Part 21 (PAR)

PART 21 REPORT - DEFECTIVE BARTON DIFFERENTIAL PRESSURE SWITCHES

PRODUCT ADVISORY

Model 288A, 289A, 580A and 581A Differential Pressure Switch Defect

MODEL 288A/289A SWITCH OPERATING MECHANISM MOCKUP
(Model 580A/581A Switch Operating Mechanism is similar)

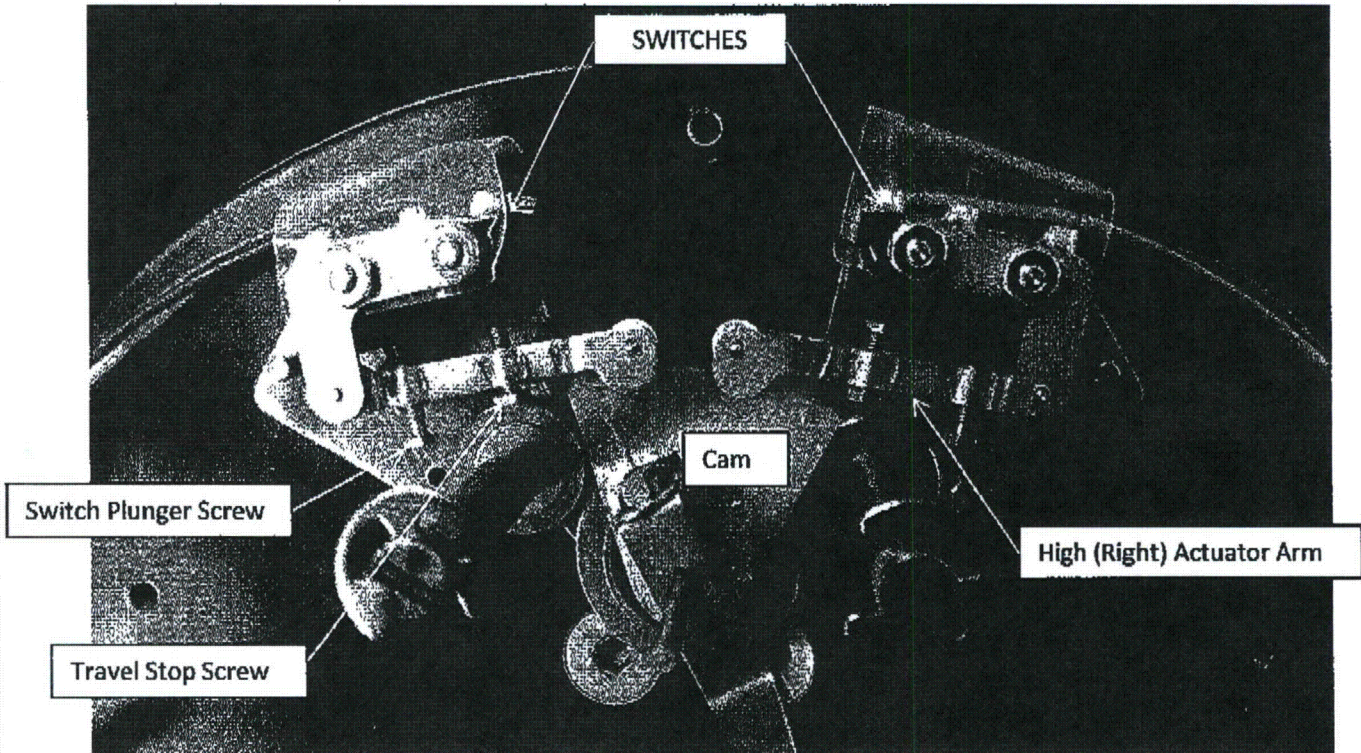
During routine receipt inspection of a recent purchase of the screws in question, some screws with undersized screw threads were discovered. During an investigation into our existing stock, Cameron discovered that the same condition also existed in some of these parts which were procured earlier this year.

Testing performed to evaluate the significance of the of the non-conforming condition revealed that the force of the miniature switch internal operating features can cause the thread "locking" material to be displaced allowing an undersized plunger screw to change its set position resulting in a change in the point where the switch will actuate (change in contact position). Screws with conforming threads did not demonstrate the same issue. The maximum change in screw position observed during this testing effort equates to a switch set point change of approximately 8.4% of the instrument's factory calibrated span.

Cameron recommends that utilities perform increased switch set point verifications on the instruments affected by this notification. It is not possible to determine which of the switches might have nonconforming switch plunger screws. Therefore, Cameron recommends that new switch actuator arm assemblies be replaced on any unit that is evaluated to be a concern by our customers. These replacement parts are available in the Cameron stock system and will be supplied free of charge for any of the products included within the scope of this notification. The P/N's for the replacement assemblies are identified on the following page.
